Proton Driver
Vacuum Chamber
Research and Development

ERRATA
7/20/2000

**Evan Malone
Beam Physics Department
Beams Division
Fermilab**

Aluminum Nitride Filled Epoxy
Reinforced with Silicon Carbide Fiber
3mm Wall
Vacuum Stress and Displacement

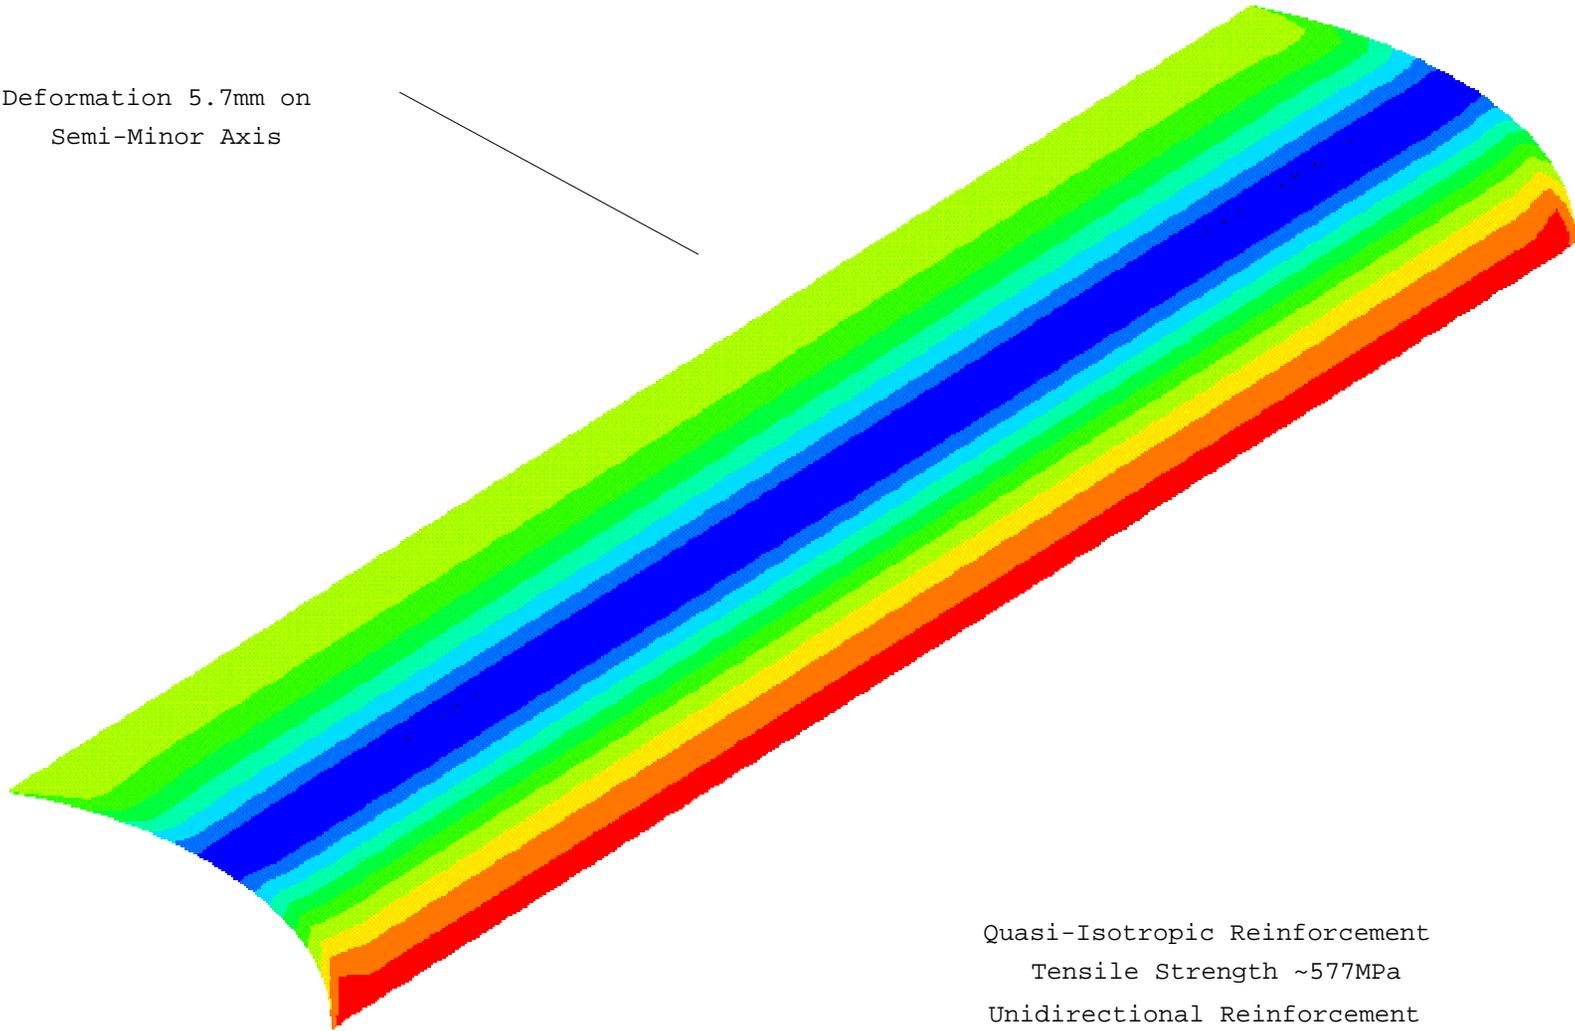
3. The linear statics stress/displacement simulation result for the "Fiber Reinforced Epoxy Composite" do not take into account the reduction of material modulus with temperature. The simulation results shown are for room temperature conditions.

Aluminum Nitride Filled Epoxy
Reinforced with Silicon Carbide Fiber
Lined with 10 micron Inconel Foil
3mm Wall Thickness
Thermal Conductivity 1 W/m*K

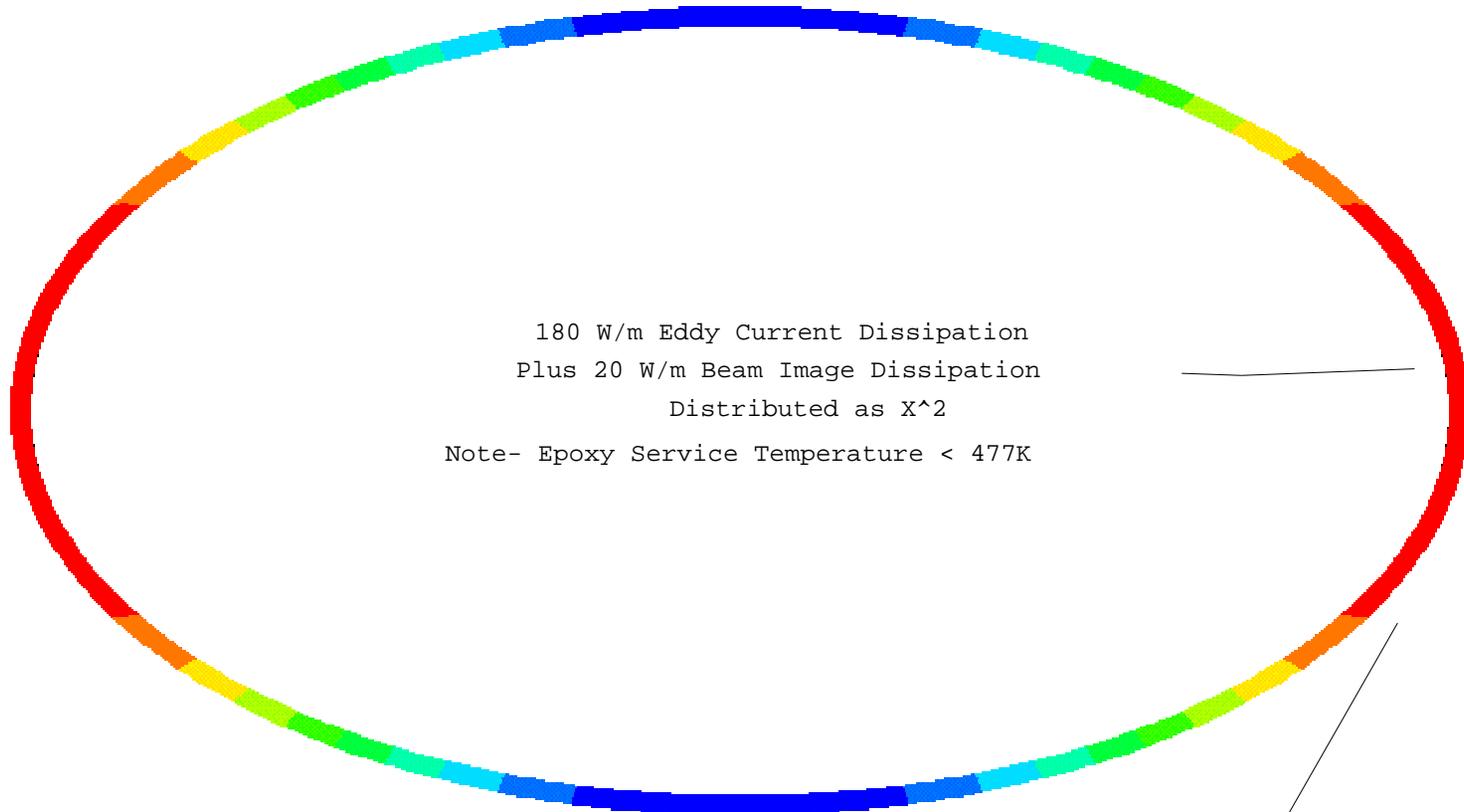
2. Please note that none of the thermal simulations described in this presentation accounted for cooling via radiation.

0.13mm Inconel Tube
Reinforced with 50 Ribs/m
Thermal Response

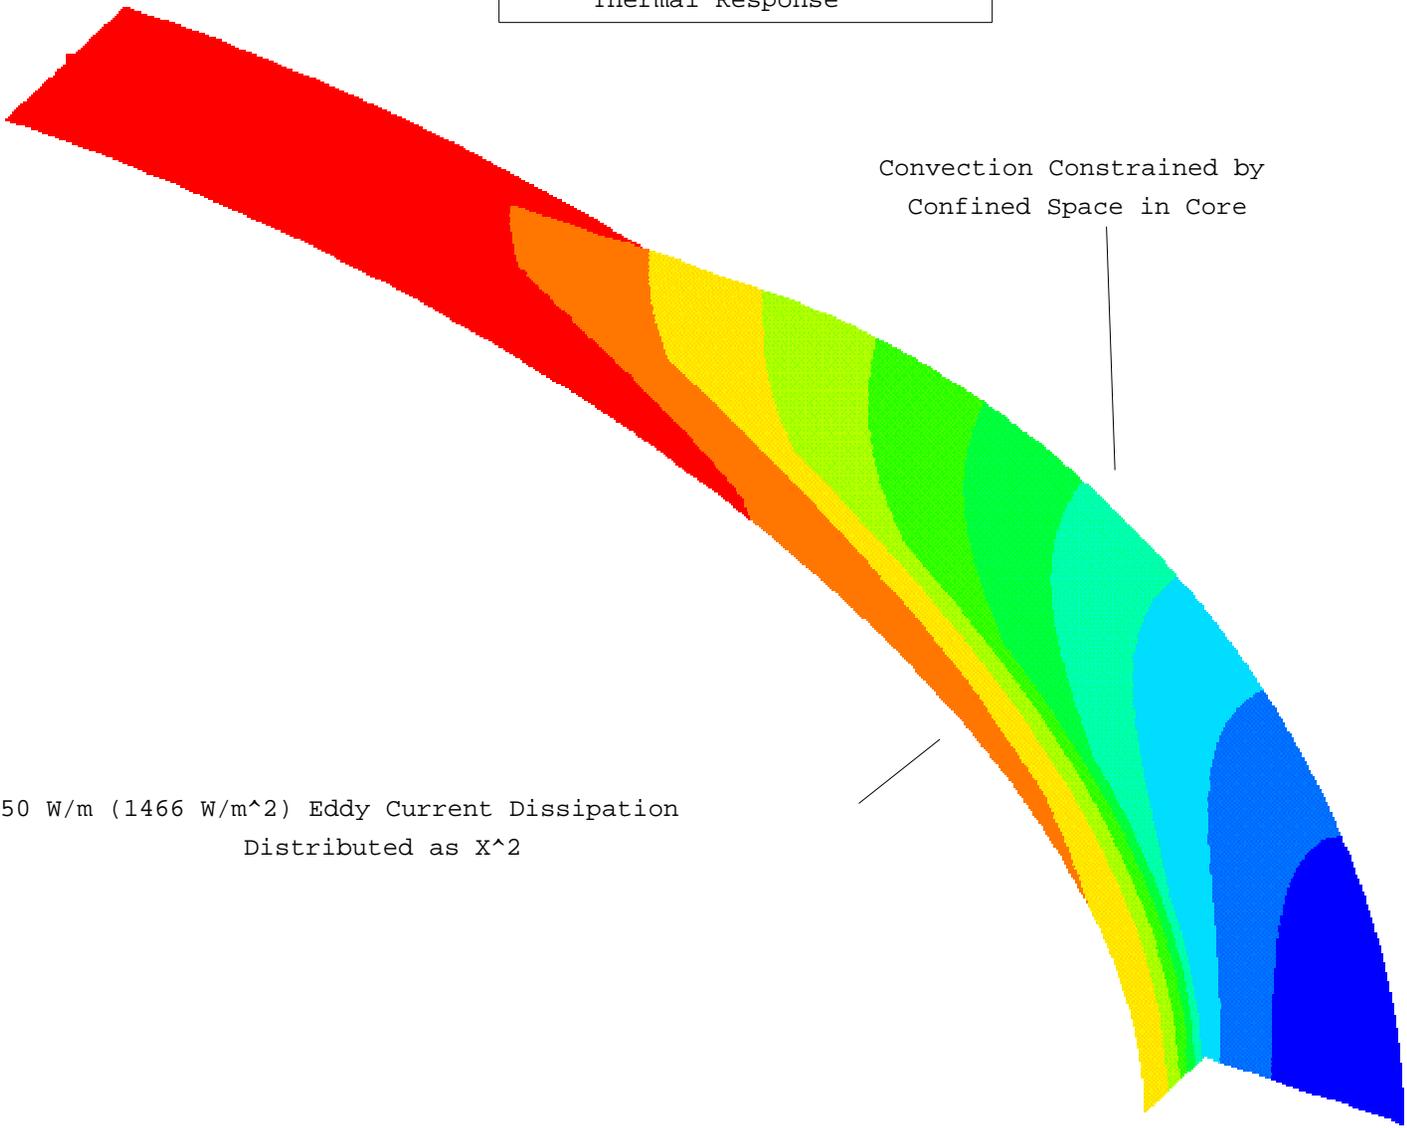
1. Following the Technical Design Review in April 2000, an error was discovered in one of the finite element simulations of the "Very Thin Rib Reinforced Tube." The operating temperature shown for this design in the charts and the graphical display of simulation results for this design are invalid. These errors resulted from a peculiarity in I-DEAS MS4 in the application of functionally distributed boundary conditions to surfaces of a model which is not analogous to the application of functionally distributed boundary conditions to model edges. Neither the heat load nor the convection boundary conditions were of the proper magnitudes. This error did not occur in other simulations as all functionally distributed boundary conditions in other models were applied to model edges only.

As time permits, corrected thermal models for the "Very Thin Rib Reinforced Tube" will be run and posted on this site.
